Access Compliance Report Public Rights-of-Way (Curb Ramps)

Main Street: N/A Cross Street: SENDERO_WAY Location: W

ADA ID: RPRK211122125352 Ramp Type: Type 7 - Directional 2 Initial Pass/Fail: Fail Overall Compliance: No Severity Score: 15

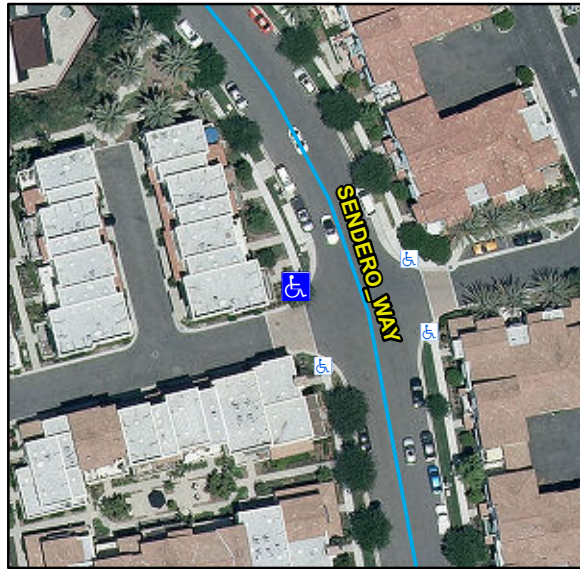
Compliance	Description	Data	Compliance	Description	Data
N/A	Ramp Length (in)	106	N/A	Flare Type LT	
Yes	Ramp Width (in)	48			N/A
No	Ramp Run Slope (%)	8.9	N/A	Flare Slope LT (%)	N/A
Yes	Ramp Cross Slope (%)	1.3	N/A	Flare Traversable LT	N/A
N/A	Grade Break	N/A	N/A	Flare Type RT	
N/A	Grade Break Slope (%)	N/A			N/A
N/A	Grade Break Cross Slope (%)	N/A	N/A	Flare Slope RT (%)	N/A
	Addl Para Ramp Left?	No	N/A	Flare Traversable RT	N/A
	Addl Para Ramp Right?	No	N/A	DWS Provided	N/A
N/A	Landing Present	N/A	N/A	DWS Contrast	N/A
N/A	Landing Length (in)	N/A	N/A	DWS Length (in)	N/A
N/A	Landing Width (in)	N/A	N/A	DWS Full Width	N/A
N/A	Landing Run Slope (%)	N/A		DWS Offset Type	N/A
N/A	Landing Cross Slope (%)	N/A	N/A	DWS Left Offset (in)	N/A
N/A	Landing Movement Obstructed?	N/A	N/A	DWS Right Offset (in)	N/A
	Landing Movement Type	N/A			
N/A	Landing Shared	N/A			
N/A	Marked Crosswalk 1	No	N/A	Clear Space	N/A
	Crossing 1 Direction	S	N/A	Clear Space To Crosswalk (in)	N/A

Remove & Replace Entire Ramp.
